Proposal for to the 04 series of amendments of Regulation No. 94 – protection of the occupants in the event of a frontal collision

Submitted by the experts from Japan on behalf of Task Force

The text reproduced below has been prepared by the expert from Japan on behalf of Task Force to amend the requirements concerning post-crash electrical safety in the event of frontal collision. The modifications to the current text of the Regulation are marked in bold for new or strikethrough for deleted characters.

Figure 3
Jointed Test Finger

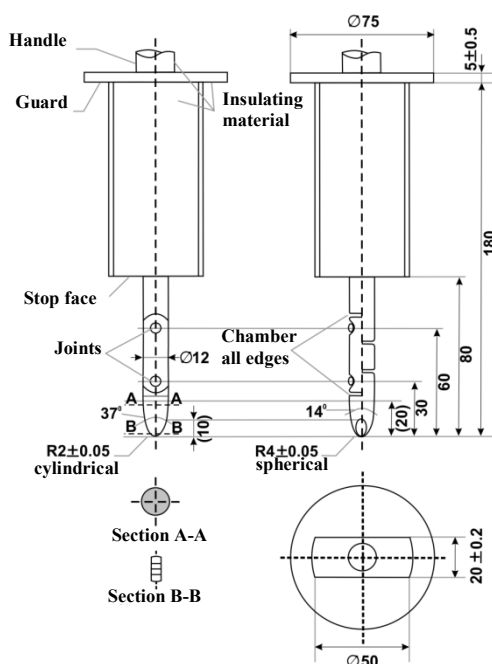
The jointed test finger described in ~~Figure 31 of Appendix 1~~ **Figure 3** shall be inserted into any gaps or openings of the physical protection with a test force of 10 N ± 10 per cent for electrical safety assessment. If partial or full penetration into the physical protection by the jointed test finger occurs, the jointed test finger shall be placed in every position as specified below.

Figure 4

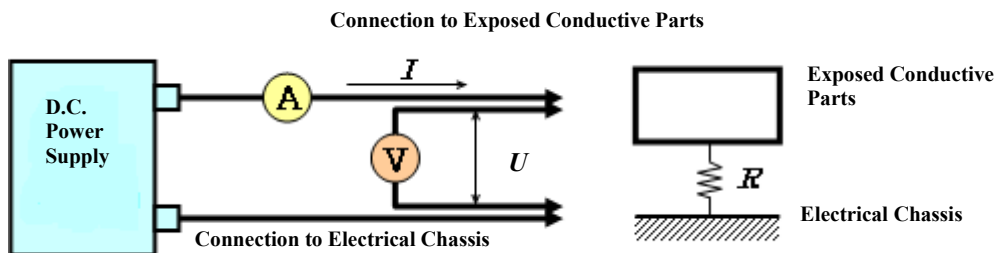
Example of the test method using DC power supply, voltmeter and ammeter is shown below.

Figure 5
Measurement of U_1'

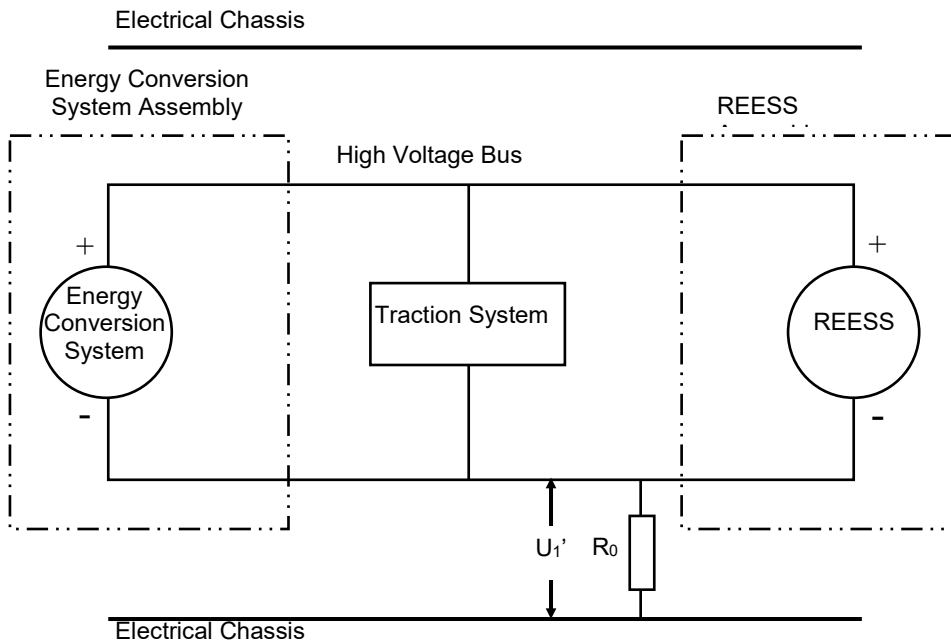
If U_1 is greater than or equal to U_2 , a standard known resistance (R_o) is inserted between the negative side of the high voltage bus and the electrical chassis. With R_o installed, the voltage (U_1') between the negative side of the high voltage bus and the electrical chassis is measured (see Figure 5).

Figure 6
Measurement of U_2'

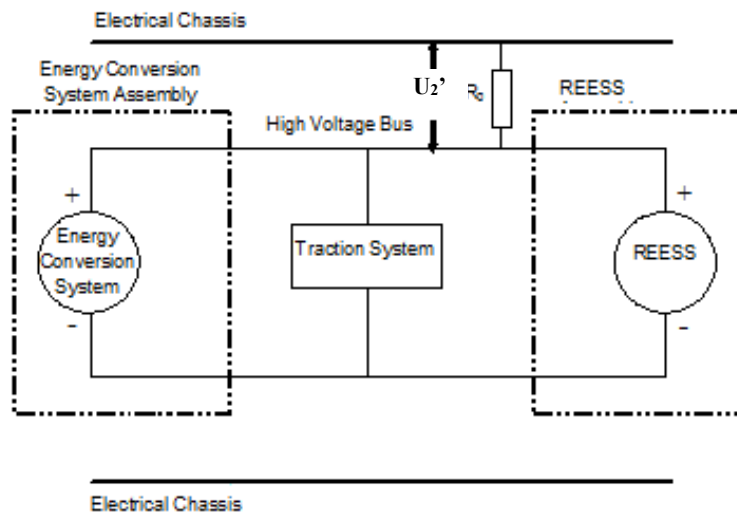
If U_2 is greater than U_1 , insert a standard known resistance (R_o) between the positive side of the high voltage bus and the electrical chassis. With R_o

installed, measure the voltage (U_2') between the positive side of the high voltage bus and the electrical chassis (see Figure 6 below). The electrical isolation (R_i) is calculated according to the following formula:
